RE: **UCCS Cyber Security - Change Order Request -
Roof Remedy @ Pre-Cast Concrete Roof Deck Areas**

Job No. 168036

Re: Re-Roof Evaluation and Fastening
UCCS National Cybersecurity Center Re-Roof
3650 N Nevada Av
Colorado Springs, Colorado

Roof Fastening Summary:

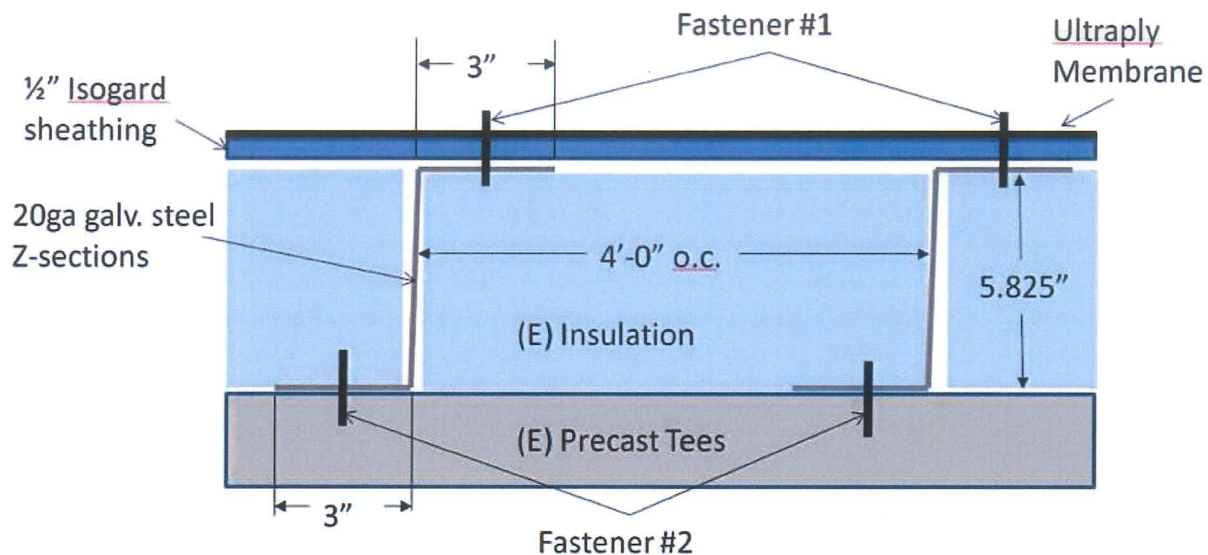
The roof system consists of a Firestone "Ultraply" roof membrane over ½" Isogard panels. These panels are supported on 20ga galvanized steel "Z" sections placed in slots cut in the existing roof insulation and fastened to the existing concrete roof deck. All materials are provided by **Central States Roof of Colorado Springs**. A design wind speed of **105 mph** (3-second gust) was used. This is the design criteria required by the provided construction documents (This exceeds PPRBD wind requirements). At the above wind speed, the ASCE 7-10 design criteria yields a maximum (zone 3) design pressure of **-87.4 psf** for the monoslope roof.

Per the information provided in the manufacturer's printed literature and our additional analysis, it is our opinion that the roof system is acceptable for the anticipated loads provided the recommended fastener spacing is used. The installed roofing will be attached to the Z-sections. Z-sections will be fastened the precast concrete roof deck as indicated below. See the figure below for reference.

- Location:** All locations (monoslope, enclosed)
- Roof Membrane:** Firestone Ultraply TPO Membrane
- Roof Sheathing:** Firestone IsoGard 1/2" sheathing
- Fastener#1:** (Roof to Z Fasteners):
 Firestone Heavy Duty Fasteners,
 1 1/2" min length
 Min 1'-6" o.c., all locations
- Z-Section:** 20ga galvanized steel min 30 ksi
 5.825" tall,
 3" flange top & bottom
- Z-section spacing:** 4'-0" o.c., perpendicular to existing precast roof tees
- Fastener #2:** (Z to Concrete Fastener)
 Steel Powder Actuated Fastener (PAF)
 Powers Fasteners part # 50016 or better)
 5/8" min embedment
 Ballistic Point
 0.150" shank
 0.300" head min diameter
 Min 2'-0" o.c. in Zones 1 and 2 (A/R-4 & B/R-4)
 Min 1'-4" o.c. in Zone 3 (C/R-4)

Roof Fastening Summary:

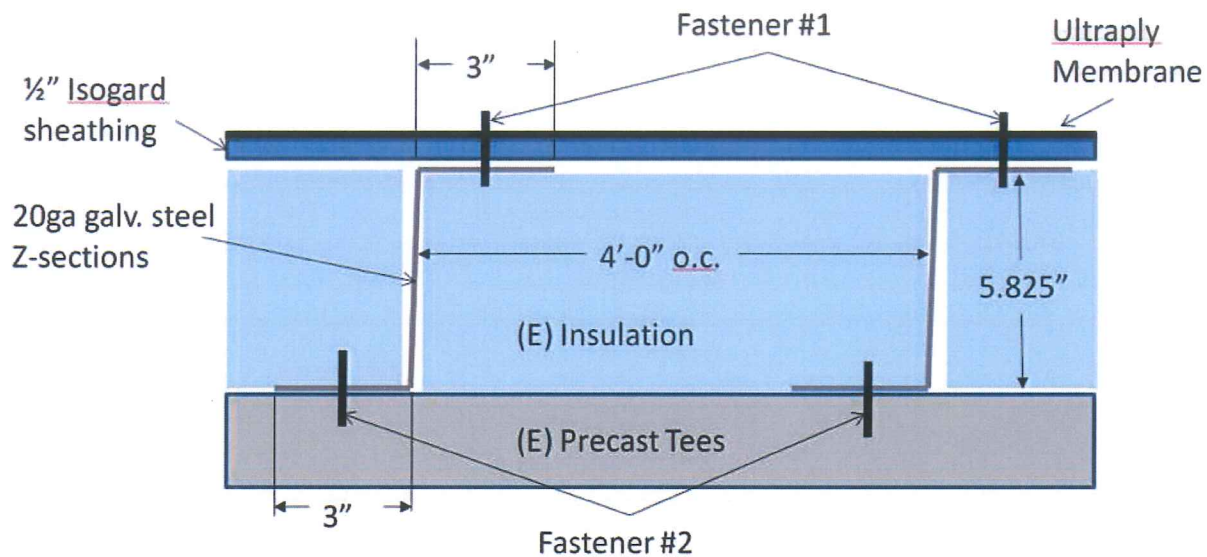
- Location:** All locations (monoslope, enclosed)
- Roof Membrane:** Firestone Ultraply TPO Membrane
- Roof Sheathing:** Firestone IsoGard 1/2" sheathing
- Fastener#1:** (Roof to Z Fasteners):
 Firestone Heavy Duty Fasteners,
 1 1/2" min length
~~Min 1'-6" o.c., all locations~~
- Z-Section:** 20ga galvanized steel min 30 ksi
 5.825" tall,
 3" flange top & bottom
- Z-section spacing:** 4'-0" o.c., perpendicular to existing precast roof tees
- Fastener #2:** (Z to Concrete Fastener)
 Steel Powder Actuated Fastener (PAF)
 Powers Fasteners part # 50016 or better)
 5/8" min embedment
 Ballistic Point
 0.150" shank
 0.300" head min diameter
 Min 2'-0" o.c. in Zones 1 and 2 (A/R-4 & B/R-4)
 Min 1'-4" o.c. in Zone 3 (C/R-4)

**Firestone
 requires Min. 12"
 o.c. J. Poe**

Firestone Building Products approves the installation as engineered by Rocky Mountain Group. Please see notes above regarding attachment.

A Insulation Attachment Pattern (Field)

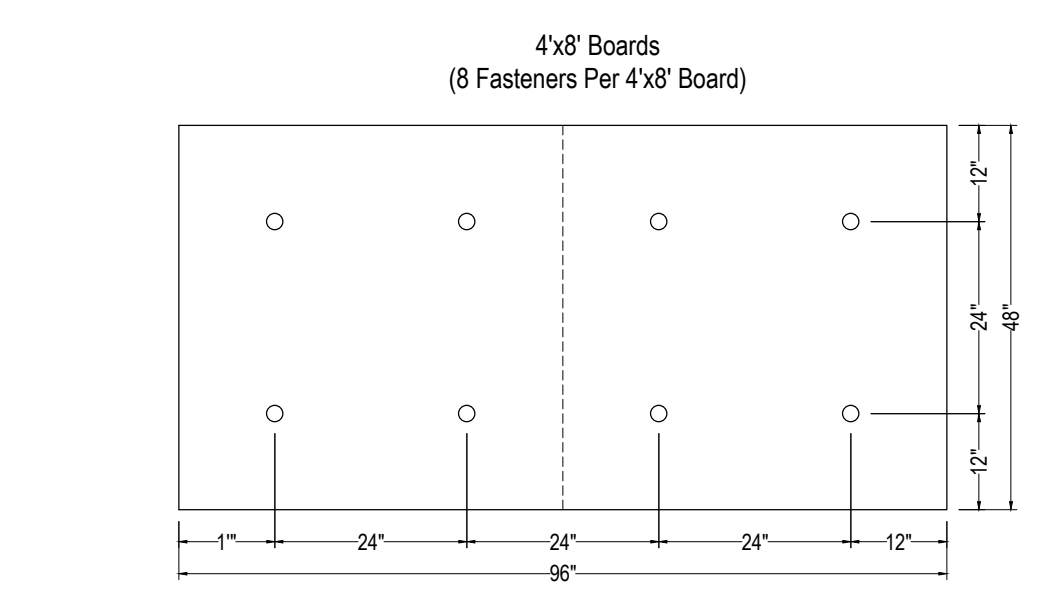
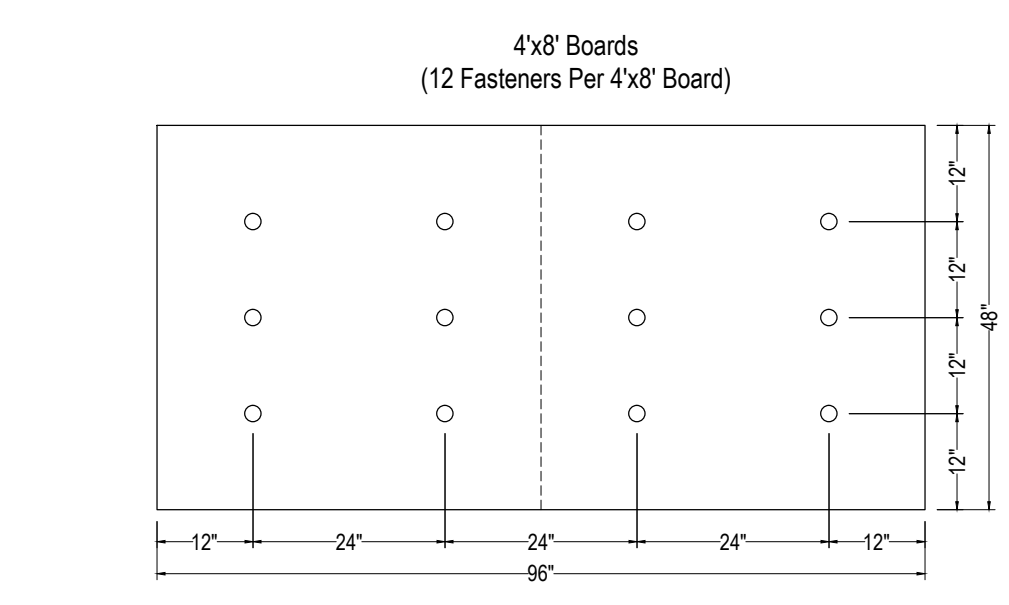
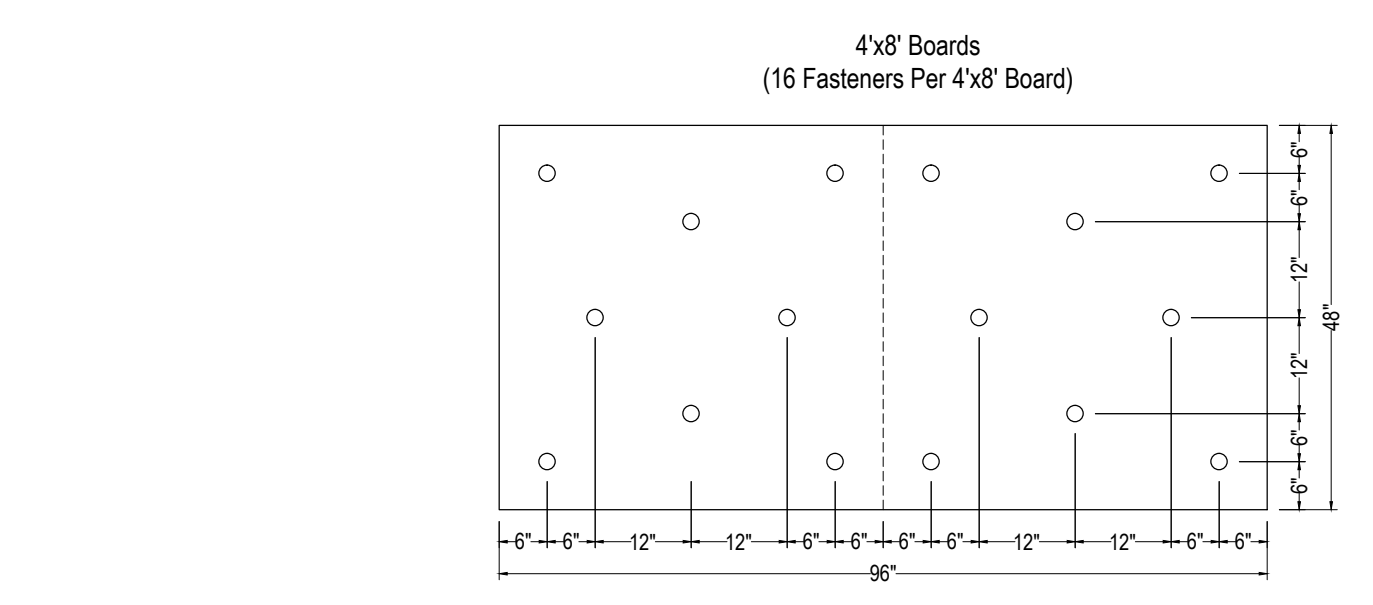
R-3 Not to Scale
20 Ga. Z Furring @ 48" o.c.
Fastener #1 - HD Fasteners @ 12" o.c.
Fastener #2 - Concrete Fasteners @ 24" o.c.

R-3 Not to Scale
20 Ga. Z Furring @ 48" o.c.
Fastener #1 - HD Fasteners @ 12" o.c.
Fastener #2 - Concrete Fasteners @ 24" o.c.

R-3 Not to Scale
20 Ga. Z Furring @ 48" o.c.
Fastener #1 - HD Fasteners @ 12" o.c.
Fastener #2 - Concrete Fasteners @ 16" o.c.
